Addendum 144 – UN Regulation No. 145

Amendment 4

Uniform provisions concerning the approval of vehicles with regard to ISOFIX anchorage systems ISOFIX top tether anchorages and i-Size seating positions

Lower Tether Anchorage Zone: Side View

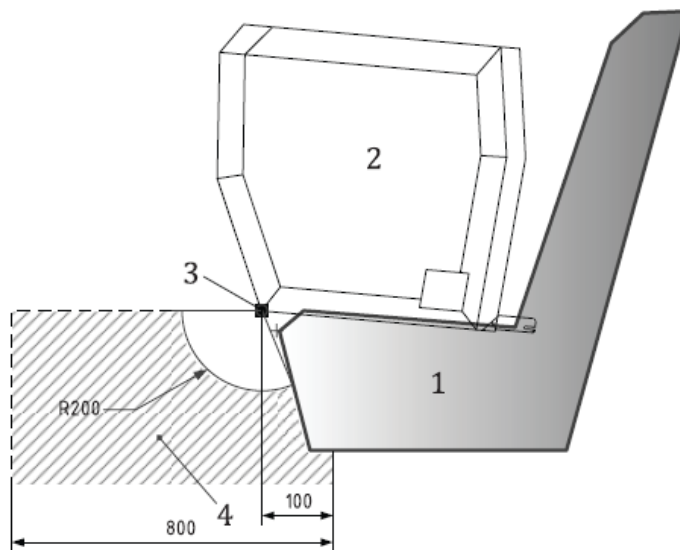
Insert new Annex 6, to read:

- Key:
1. vehicle seat illustration.
 2. ISO/R2 envelope installed in related vehicle seating position.
 3. reference point on ISO/R2 envelope for LTA zone measurements.
 4. lower tether anchorage zone in side view, with upper limitation.
 5. where the LTA is integrated with the seat in front, the zone requirements have to be fulfilled independent of the height adjustment settings of the seat in front, taking the presence of the ISO/R2 envelope into consideration.

- 5.4.2. Number and Positioning
 - 5.4.2.1. Each intended (E)CRS position may be provided with a single or two LTAs, located within the zones shown in figures 1 to 3 of Annex 6 and according to the following specifications.

Figure 2
Lower Tether Anchorage Zone: Top View

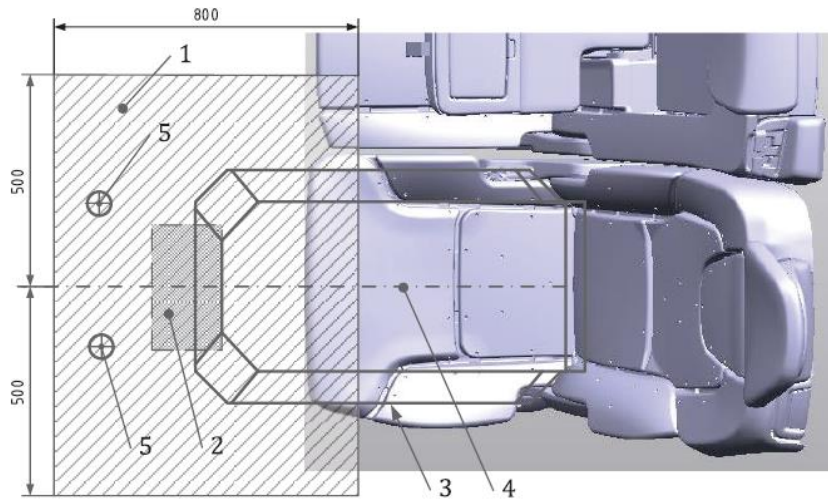
- Key:
- 1. lower tether anchorage zone, top view.
 - 2. support leg zone (not to be used).
 - 3. ISO/R2 envelope installed in related vehicle seating position.
 - 4. centreline of ISO/R2 and ISOFIX anchorage positions (or the apparent centreline of the seating position in case of non-ISOFIX/i-Size seating positions, according to Annex 6) (contour only shown).
 - 5. lower tether anchorage, example positions

Note: The rearmost surface of the zone is positioned 100 mm rear of a vertical plane through the reference point on the ISO/R2 envelope. See Figures 5 and 6."

Figure 3
Force Direction Reference Point and Direction of Test Force

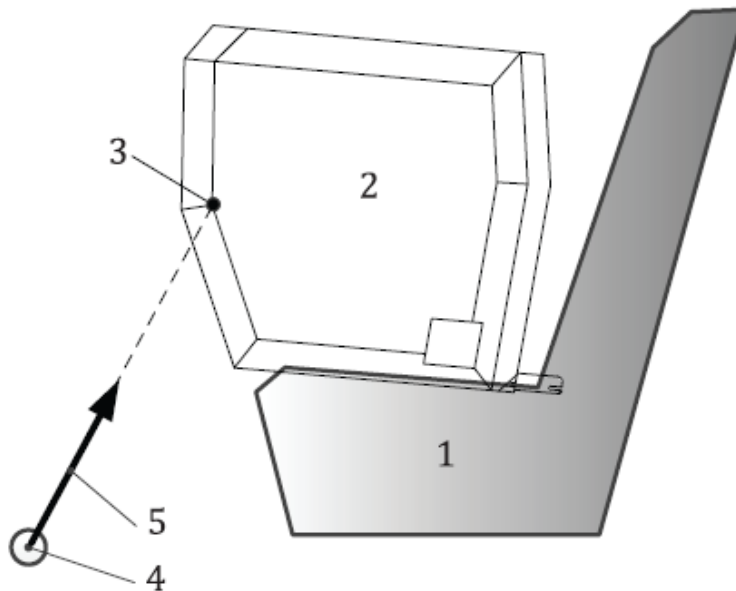
- Key:
- 1. vehicle seat illustration.
 - 2. ISO/R2 envelope installed in related vehicle seating position.
 - 3. FDRP (force direction reference point).
 - 4. example of actual LTA position in vehicle.
 - 5. test force direction.

Note: The lateral position of FDRP coincides with the centreline of the ISO/R2 envelope"

- 6.3.4. The force:
- 6.3.4.1. Shall be applied in a direction determined by the FDRP (force direction reference point), with a tolerance of \pm 20 mm in all directions given in figure 3 of Annex 6, noting that the FDRP lateral position coincides with the centreline of the ISO/R2 envelope;
